**ADDENDUM NUMBER THREE**  
**to the**  
**PROJECT SPECIFICATIONS**  
**and**  
**CONTRACT DOCUMENTS**  
**for**  
**Concrete Dams Repair Project**  
**(Project # 12-7007810-8930-09532)**

**DATE OF ADDENDUM:** April 19, 2012

**EXHIBIT "A"**  
**CONCRETE DAMS REPAIR PROJECT**  
**CITY OF PRESCOTT PUBLIC WORKS DEPARTMENT**

# UPPER GOLDWATER DAM PARAPET WALL SPALL REPAIR AND WALKWAY REPAIR

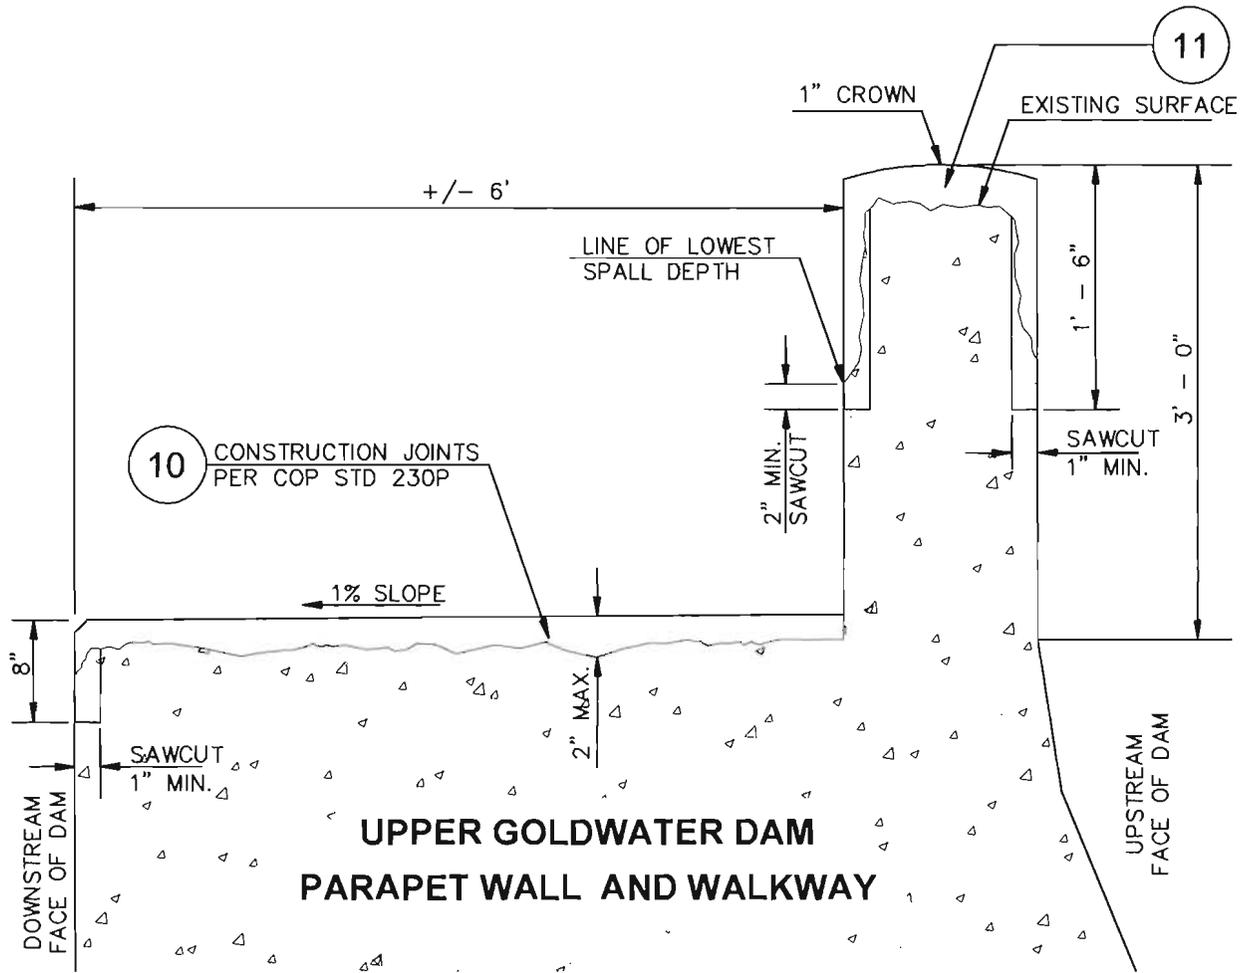
Sheet CO4 Dam Repair Details 1

Replace Upper Goldwater Dam Parapet Wall Spall Repair – 5/CO6 with the attached Exhibit “A” – Upper Goldwater Dam Parapet Wall Spall Repair and Walkway Repair.
